From: Warrior, Andrew
Sent: 20 February 2020 14:13
To: Kelsey Blain
Subject: RE: Listed Building Consent and Planning Application for Mount Misery Farm, Hackness

Project
Mount Misery Farm

Content
Yorkshire Light Window Details and Sections

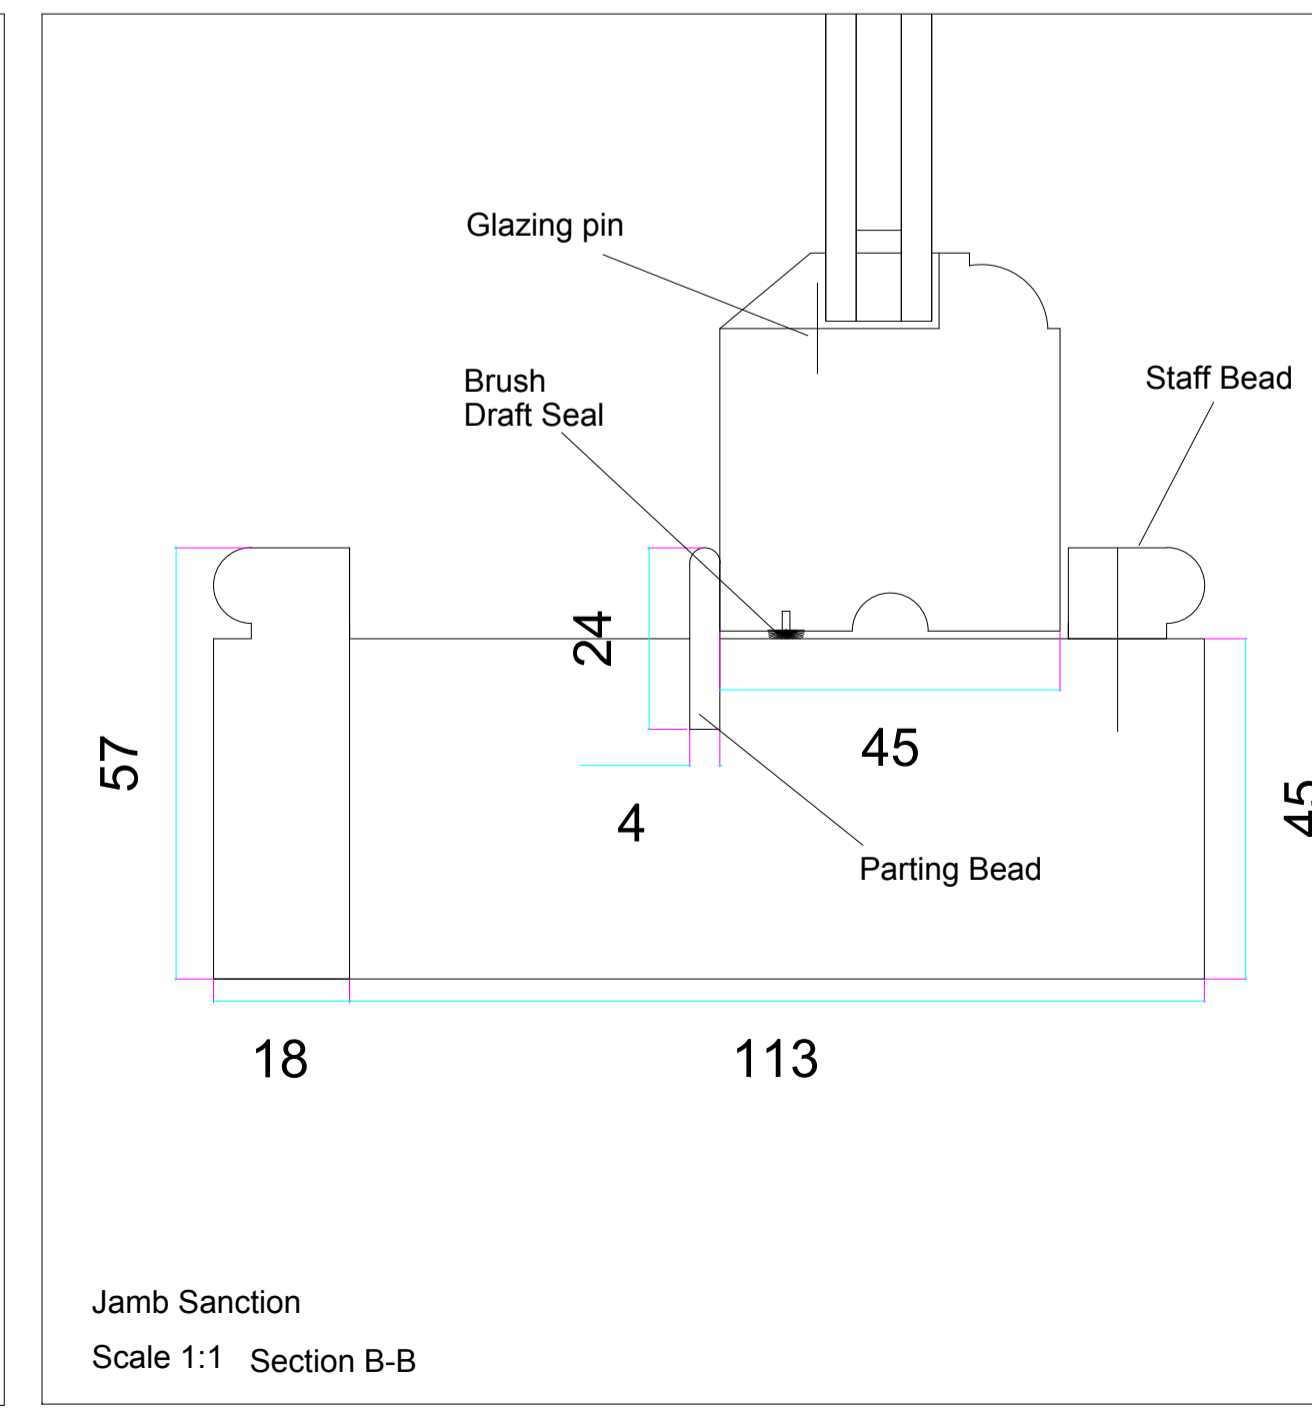
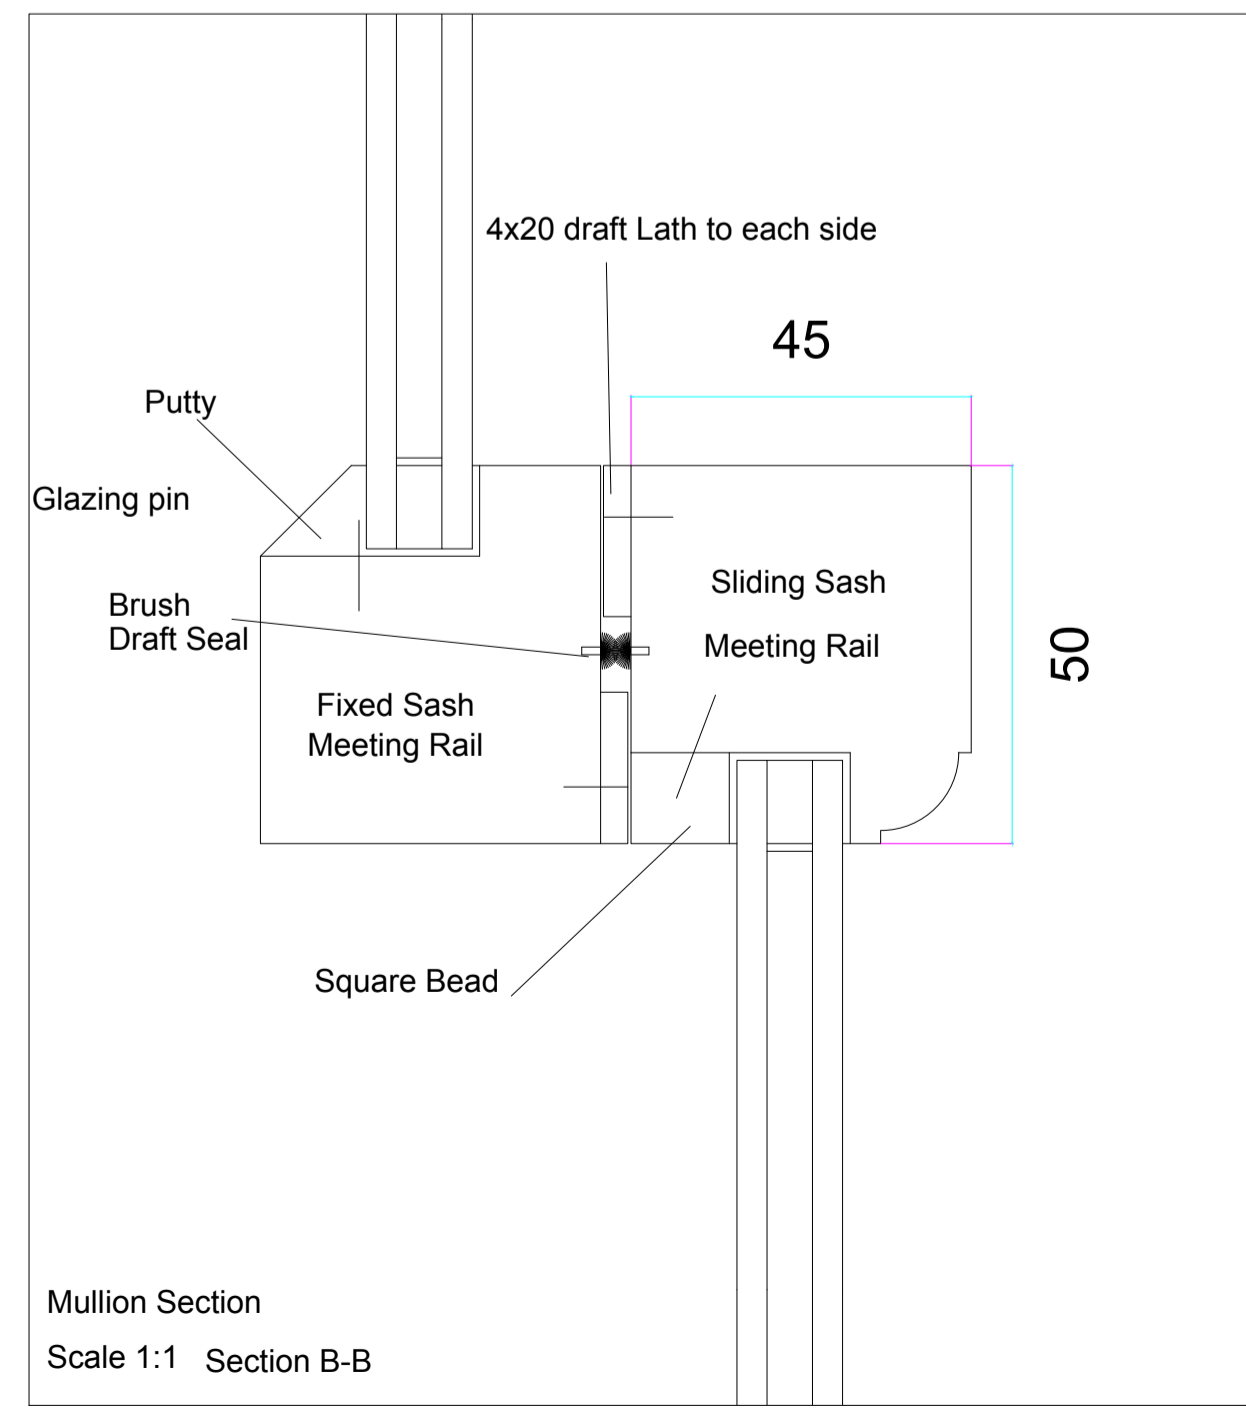
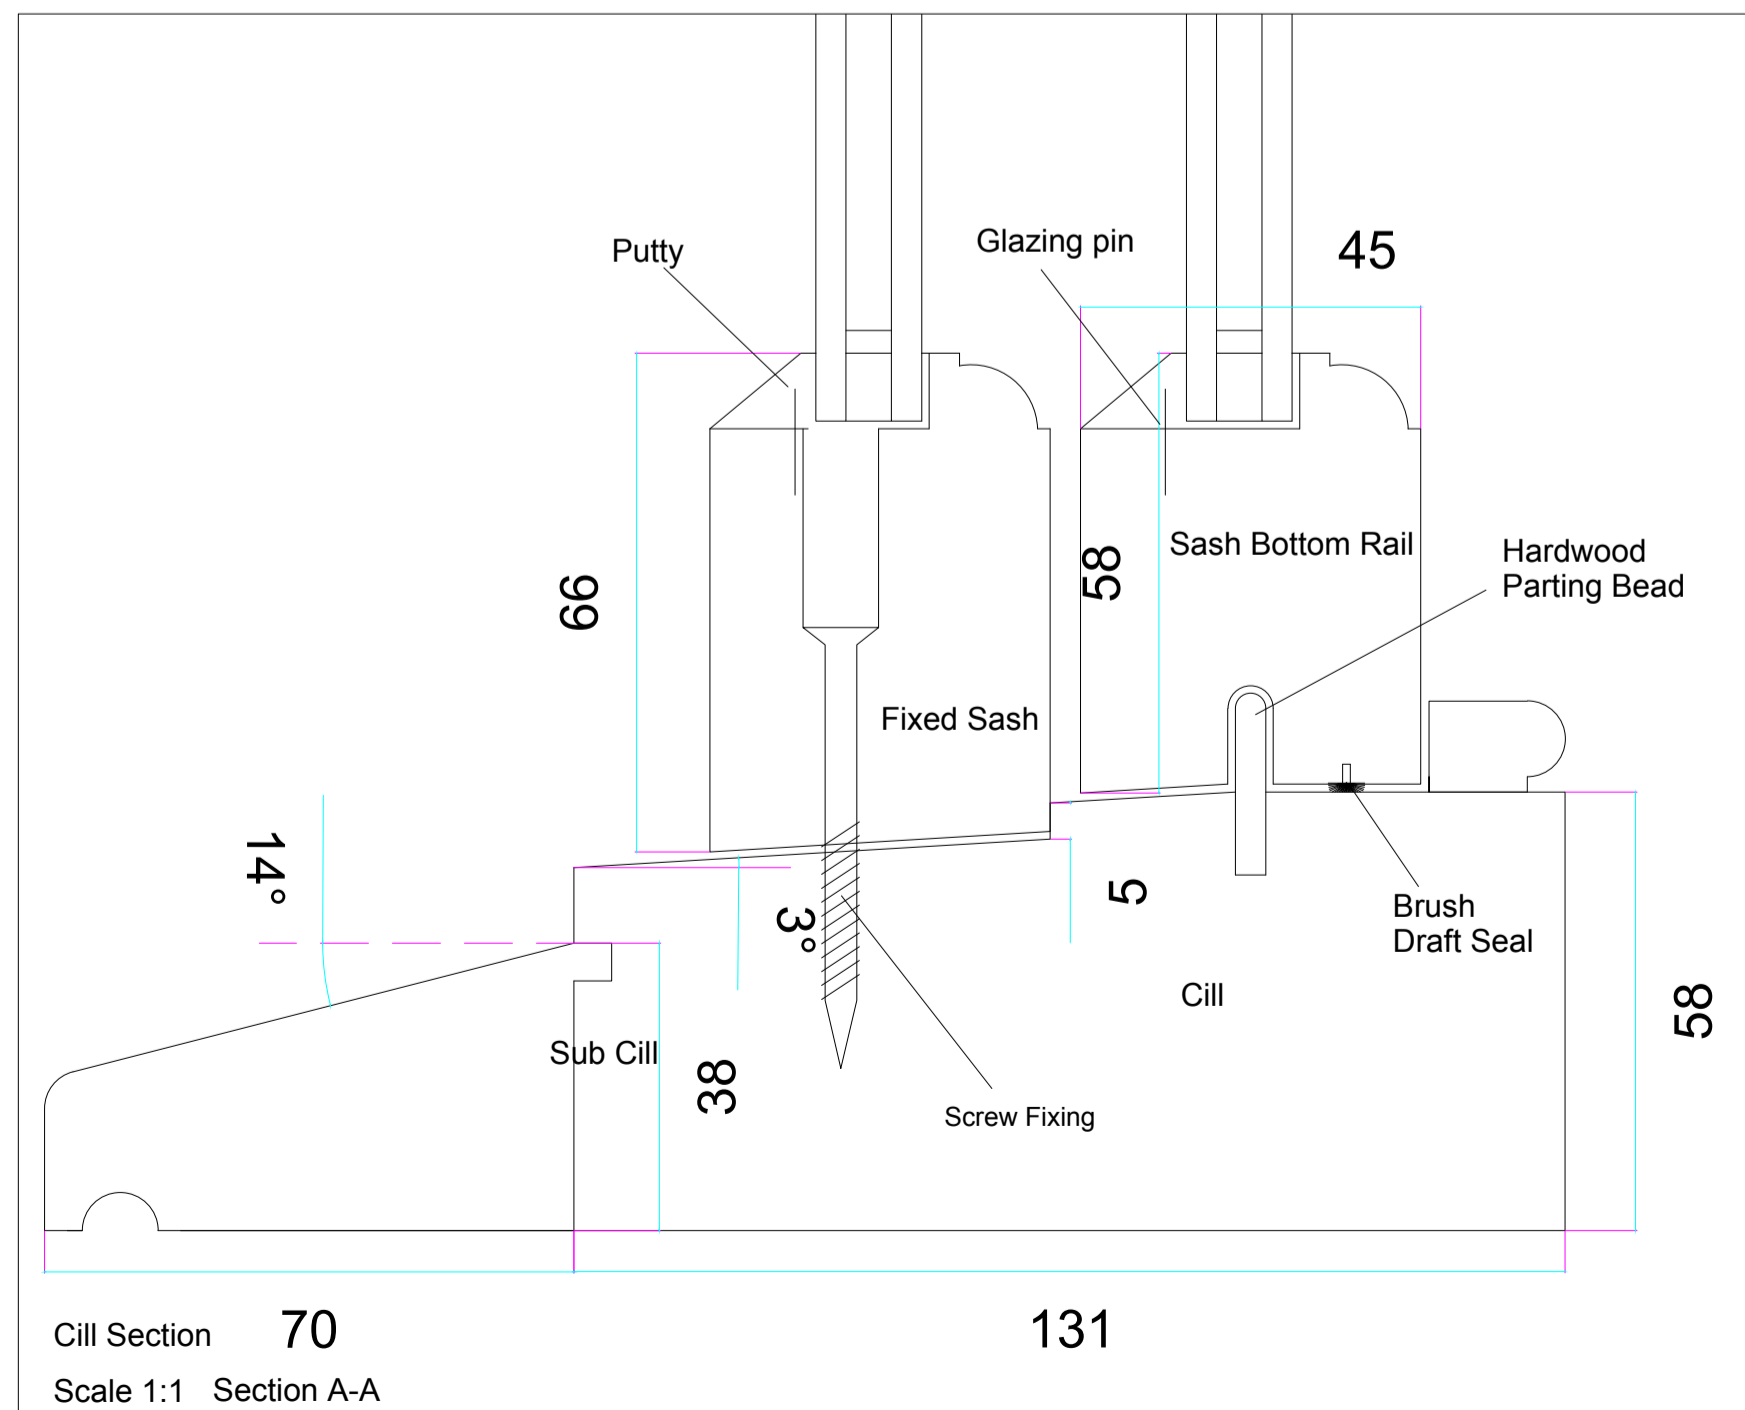
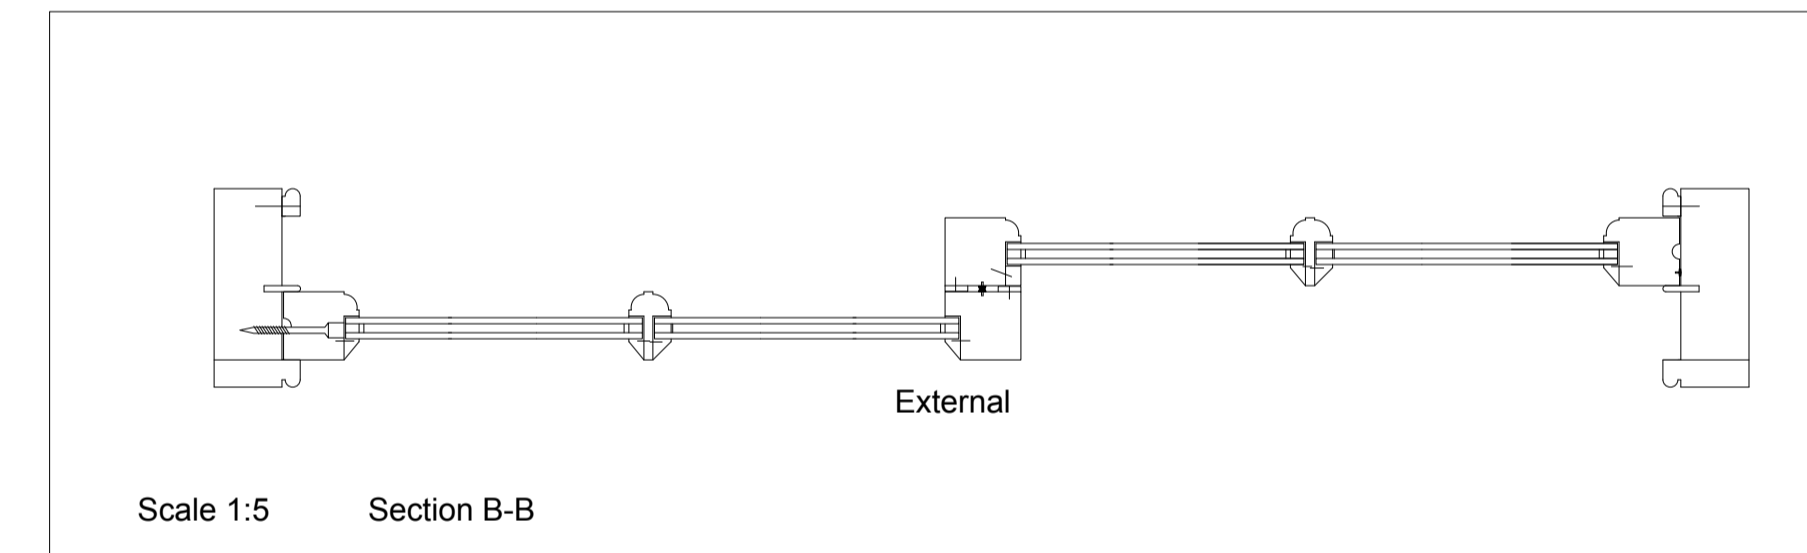
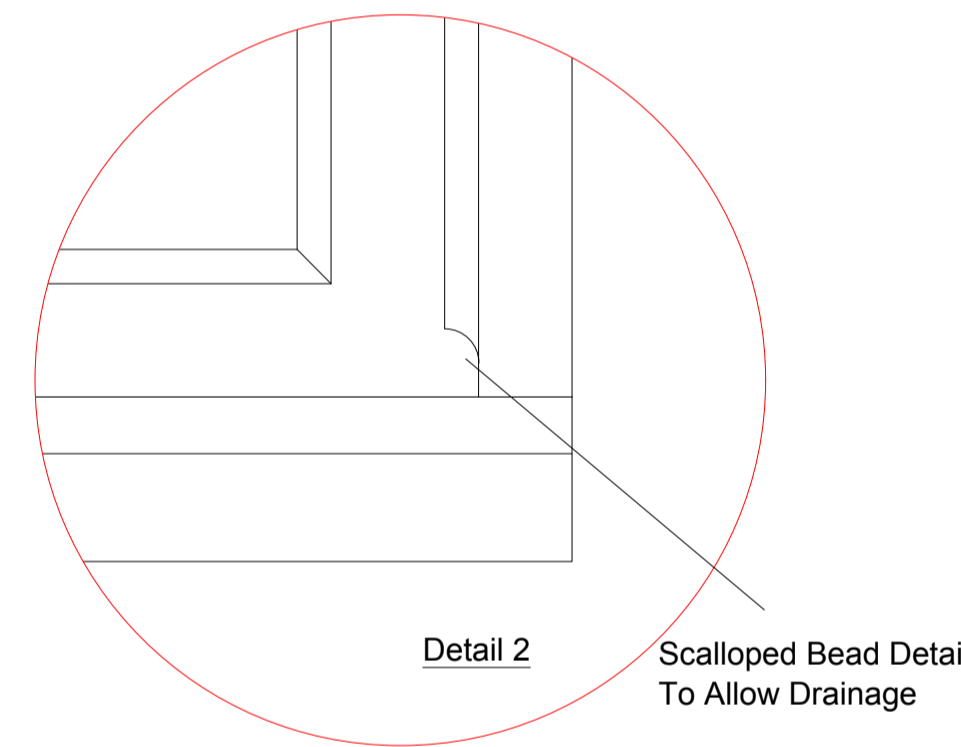
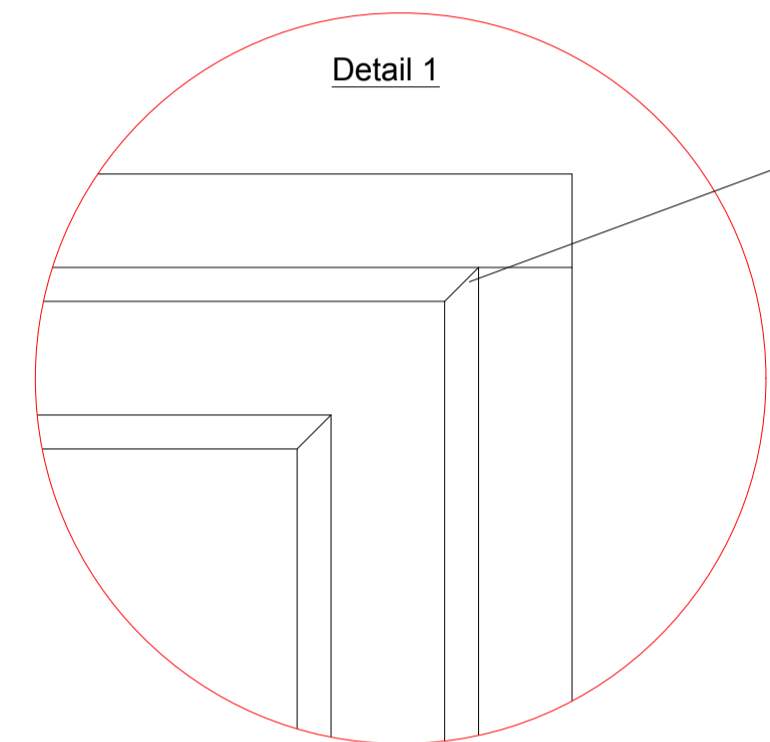
Thank you for your response. Please find attached a plan from a recent application which includes the details requested by the Building Conservation Officer. The Building Conservation Officer has also stated that they will accept 26mm glazing bars if other details (shown on the attached plan) could be replicated. They have requested that the details and approach also be replicated in the casement window.

Furthermore, whilst we appreciate the casement window being amended to a fixed sash, may I request that the design of this sash be amended to replicate that of the sashes on either side. This will remove the thick transom from the central sash which is the non-traditional element within this window.

Caseament window:

- Omission of the central top opening section which isn't a traditional arrangement. Central pane should be fixed with just the two side panes opening.
Top casement sash can be fixed

- Use of glazing putty to hold the glass, not beads. You can get putty which is compatible with d/g units.
Although timber beading would be more suitable for double glazed units and the profile would look like putty as the timber beading in the photo you provided (Attached) I would be able to specify putty

- Reduction in the size of the glazing bar, down to 22mm if possible?
As we are fitting double glazed units it would not be possible to reduce the size of the glazing bars. The double glazed unit spacing bar has a depth of 10mm, the rebate and the glass should have a 2mm clearance this is why the rebate depth has to be 12mm. When fitting beads to hold the unit in place the feather has to be sufficient to provide a secure fixing for the pins as you have requested putty the thickness of the feather is crucial to provide a safe and secure fixings.

- Omission of the drip moulds.
The drip mould is good practise but will be removed
- Could consideration be given to use of a leaded cill, rather than a projecting cill – see example attached.
The projecting cill is preferred as it will allow water to drain away from the building and prevent the water from traveling back in to the building by capillary action.

I also omitted to say the casement windows will be hung on butt hinges and they will be held shut by traditional window stays and fasteners.
